Access Compliance Report Public Rights-of-Way (Curb Ramps)

Main Street: WHITNEY_DR Cross Street: MALENA_DR Location: NW

ADA ID: RPAT211001114358 Ramp Type: Type 1 - Perpendicular Diagonal Initial Pass/Fail: Fail Overall Compliance: No Severity Score: 16

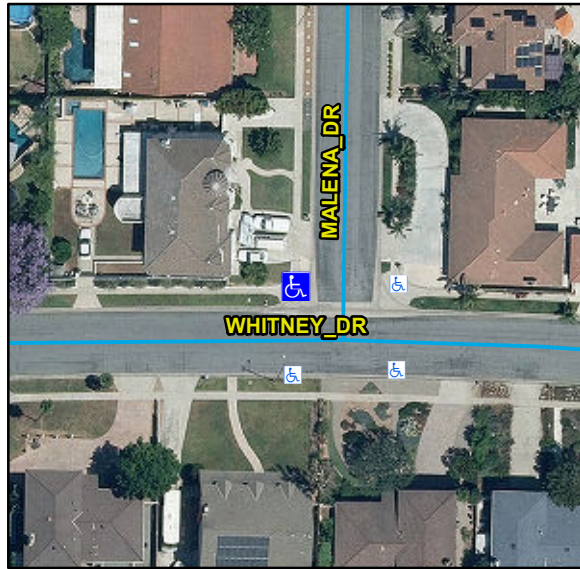
Compliance	Description	Data	Compliance	Description	Data
N/A	Ramp Length (in)	89	N/A	Flare Type LT	
Yes	Ramp Width (in)	50			N/A
No	Ramp Run Slope (%)	8.7	N/A	Flare Slope LT (%)	N/A
No	Ramp Cross Slope (%)	2.9	N/A	Flare Traversable LT	N/A
N/A	Landing Present	N/A	N/A	Flare Type RT	
N/A	Landing Length (in)	N/A			N/A
N/A	Landing Width (in)	N/A	N/A	Flare Slope RT (%)	N/A
N/A	Landing Run Slope (%)	N/A	N/A	Flare Traversable RT	N/A
N/A	Landing Cross Slope (%)	N/A	N/A	DWS Provided	N/A
N/A	Landing Movement Obstructed?	N/A	N/A	DWS Contrast	N/A
	Landing Movement Type	N/A	N/A	DWS Length (in)	N/A
N/A	Landing Shared	N/A	N/A	DWS Full Width	N/A
N/A	Clear Space	Yes	N/A	DWS Offset Left (in)	N/A
N/A	Clear Space To Crosswalk (in)	N/A	N/A	DWS Offset Right (in)	N/A
N/A	Marked Crosswalk 1	No	N/A	Marked Crosswalk 2	No
	Crossing 1 Direction	S		Crossing 2 Direction	E
	Marked Crosswalk 1 Width (in)	N/A		Marked Crosswalk 2 Width (in)	N/A

Remove & Replace Curb Ramp With Two New Directional Ramps or Equivalent.
